Subject: Progress Energy Florida Levy Nuclear Plant Units 1 and 2

This letter provides additional clarifying information in response to comments raised in your letter to the DEP Siting Coordination Office, dated August 27, 2008. Please note that the attachments referenced in the response below are being provided to FWC and DEP Siting Coordination Office only.

Subject: Progress Energy Florida Levy Nuclear Plant Units 1 and 2

This letter provides additional information in response to comments raised in your letter to the DEP Siting Coordination Office, dated August 26, 2008.

Temperature vs. Distance from Discharge Canal

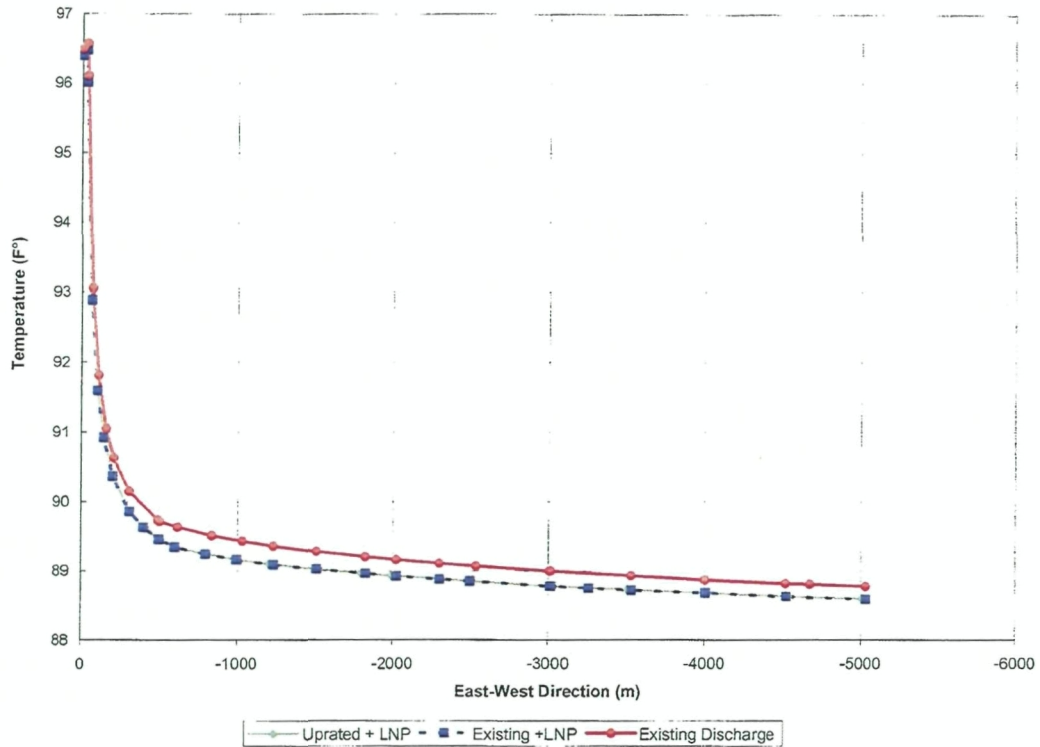
**Progress Energy has provided the details of the "COLA Aquatic Sampling Workplan" dated March 2008 (RAI Number: LNP SCA RAI-I07). In the review of the workplan, it does not appear that benthic monitoring of seagrasses is planned or is being conducted. We request additional information on procedures that Progress Energy will employ to monitor impacts to seagrass beds. If no plan has been developed, we recommend that seagrass monitoring studies be incorporated into the workplan. Further, we recommend that these surveys should include: 1) seagrass species identification and location, 2) delineation of seagrass patch distribution if seagrass distribution is not continuous within the current and projected thermal plume, and 3) areal percent cover by species. We request that Progress Energy provide a map showing seagrass distributions by species (with densities or areal coverage) within the current and projected thermal plume.**

The proposed LNP discharge will be a lower temperature than the existing CREC discharge and it will not cause or contribute to a greater thermal footprint in the zone of discharge at the end of the CREC discharge canal. As a result, the temperature of the combined LNP and CREC discharge is projected to be slightly lower than the temperature of the discharge from the existing CREC units. Discharge details are provided in the following table.

By adding the lower temperature LNP discharge, the overall temperature of the combined discharge plume is not expected to increase with distance. The 4 percent additional flow rate from LNP, with a lower temperature, will contribute to more dilution in the Gulf of Mexico. The existing CREC plume stratifies into a shallower surface layer because the higher temperature plume is slightly less dense than ambient Gulf waters. The more stratified existing condition results in more buoyant lateral spreading (i.e., the plume would be "squeezed" into a thinner layer), resulting in a plume area with less vertical mixing, covering a larger area. Adding the LNP discharge to the CREC discharge stream will cause the combined plume to be slightly denser because of lower temperature and slightly higher salinity. There will be slightly more vertical mixing under the proposed conditions, which will result in a more rapid reduction in temperature over distance and a smaller area of dispersion. The comparison between the existing and proposed discharges, as estimated with plume dilution modeling, indicates that the addition of the LNP discharge to the existing CREC discharge will have no significant or discernible effect on the thermal footprint of the CREC discharge, as illustrated in the following figure.

Figure 1. Temperature vs. Distance from Discharge Canal

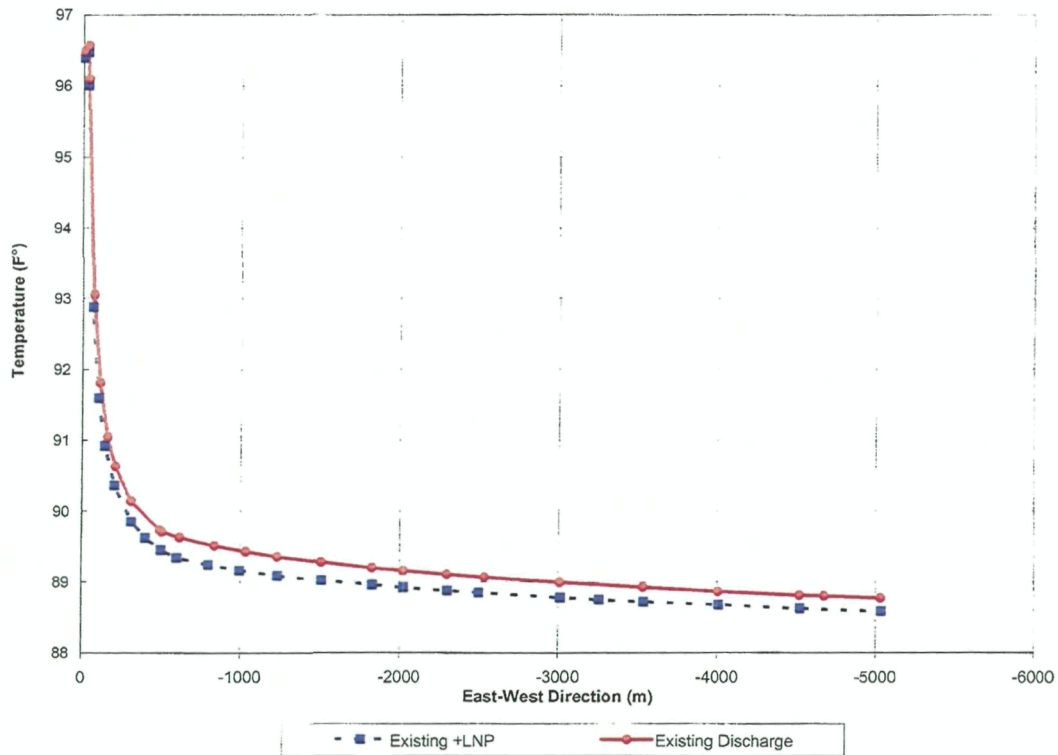
**Section 5.3.2.1 identifies that discharge for the Levy nuclear plant will equal an additional 81 million gallons per day of heated water. As such, the Levy Nuclear Plant discharge represents a significant increase in cumulative heat energy that will require additional mitigation. Average temperature may or may not measurably decrease, but how will more heated effluent affect other physical properties capable of producing impact? What additional control technologies could yield beneficial mitigation of impact to regionally significant waters, fisheries and aquatic ecosystems? What other options exist outside of control technology to reduce the impact of increased heat discharge flow?**

The change in the heat load at CREC due to the addition of the LNP discharge is not significant (that is, only a 2.3 percent increase) when compared with CREC's existing operations. No impacts to other physical properties resulting from LNP heat loading will occur. The cooling system to be used at the LNP facility is considered to be the best available technology and additional controls, such as the helper cooling towers, are in place at CREC to maintain the discharge within permitted limits. Since there is no discernable temperature increase or expansion of the thermal footprint, additional control technologies or the employment of other options is not necessary.

Please refer to the response to Comment 5 for background information on the LNP discharge and the expected combined flow characteristics at the CREC discharge canal. Combining the lower temperature LNP discharge with the CREC discharge is not expected to increase the overall temperature of the combined discharge plume with distance. In fact, the 4 percent increase in flow volume from LNP will result in more dilution of the thermal plume. The comparison between the existing and proposed combined discharge streams, as estimated with plume dilution modeling, indicates that the addition of the LNP discharge to the existing CREC discharge will have no significant or discernible effect on the thermal footprint of the CREC discharge, as illustrated in the following figure.
